MINERALS PROGRAM INSPECTION REPORT
PHONE: (303) 866-3567

MINE NAME: Cresson Project	MINE/PROSPECTING ID#: M-1980-244	MINERAL: Gold	COUNTY: Teller
INSPECTION TYPE: Monitoring	INSPECTOR(S): Timothy Cazier, P.E.	INSP. DATE: April 29, 2021	INSP. TIME: 09:00
OPERATOR: Cripple Creek & Victor Gold Mining Company	OPERATOR REPRESENTATIVE: Katie Blake & Dylan Noble	TYPE OF OPERATION: 112d-3 - Designated Mining Operation	
REASON FOR INSPECTION: Normal I&E Program	BOND CALCULATION TYPE: None	BOND AMOUNT: \$159,491,188.00	
DATE OF COMPLAINT: NA	POST INSP. CONTACTS: None	JOINT INSP. AGENCY: None	
WEATHER: Clear	INSPECTOR'S SIGNATURE: 	SIGNATURE DATE: June 4, 2021

Photo 7. South Cresson, east highwall angle at $\sim 58^\circ$ (looking north).

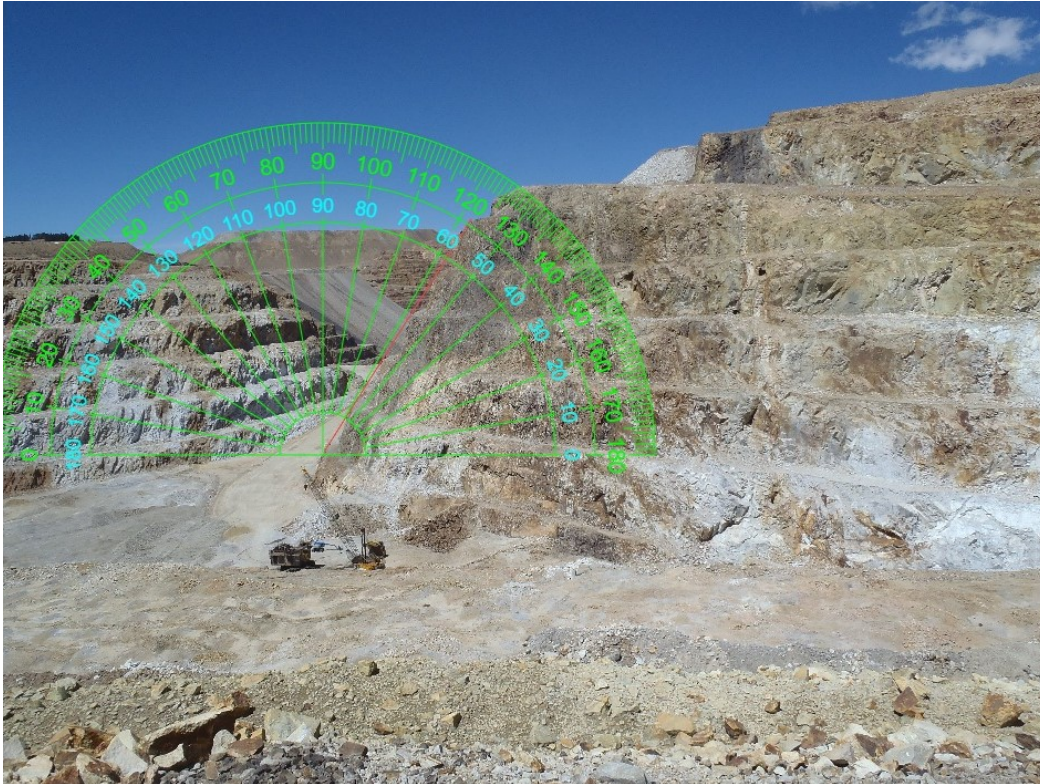
South Cresson Highwall: The South Cresson highwalls were inspected to observe bench configurations. Benches were more defined than what appeared in DRMS aerial images. Although bench crests appeared more rounded than in the adjacent Main Cresson pit (see **Photo 6**). An image taken of the east South Cresson highwall indicates the overall slope is $\sim 58^\circ$ (see **Photo 7**). The East Cresson west highwall bench crests are also somewhat rounded, limiting rockfall catchment capacity (see **Photo 8**). Site representatives were asked if the highwalls were scaled to limit rockfall. They indicated it was likely not common, but would check with Mine Operations to get a more definitive answer.

Photo 10. Widened embankment on SW side of PSES holding pond (note low point directs overflow off liner).

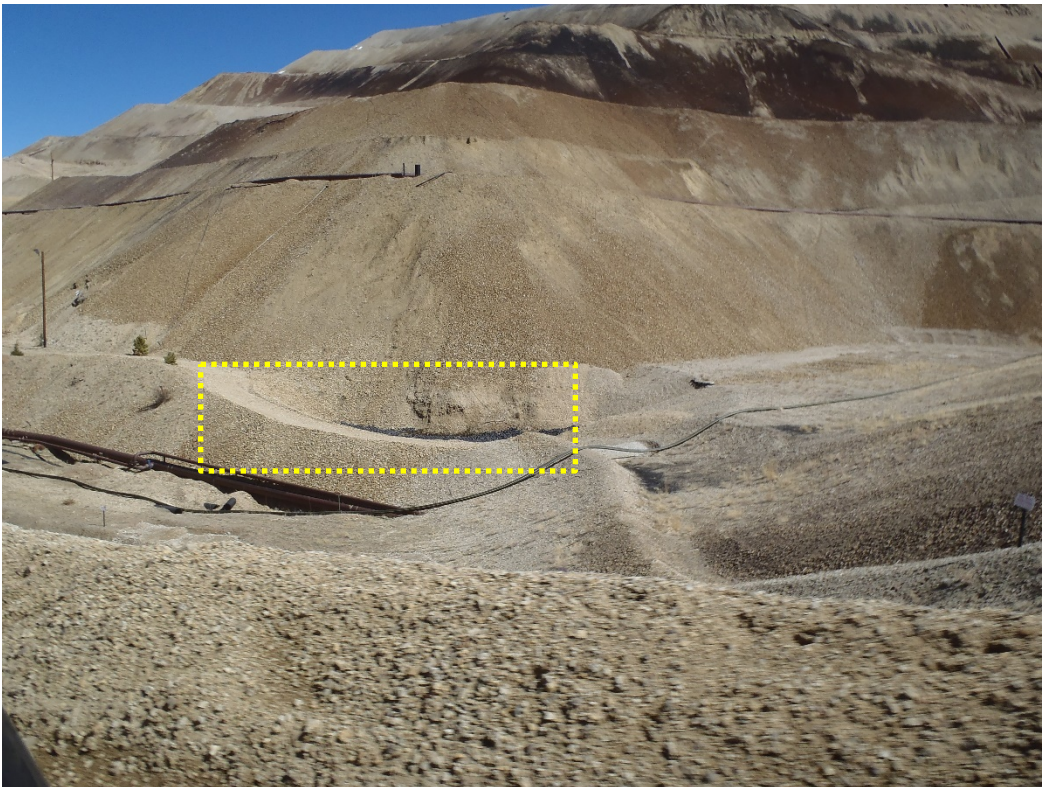
- New wildlife fencing was observed along the road between the VLF1 Phase V pumps and Hwy 67 just west of the city of Victor (see **Photo 9**).
- The widening of the berm/embankment for the holding pond west of the PSES (cited as having potential containment concerns in our June 30, 2020 inspection) was observed (see **Photo 10**). This embankment is still the low point where if capacity is exceeded, potentially impacted water would flow off the lined area. However, the widening of the embankment crest will reduce the potential for it to breach from overtopping erosion.
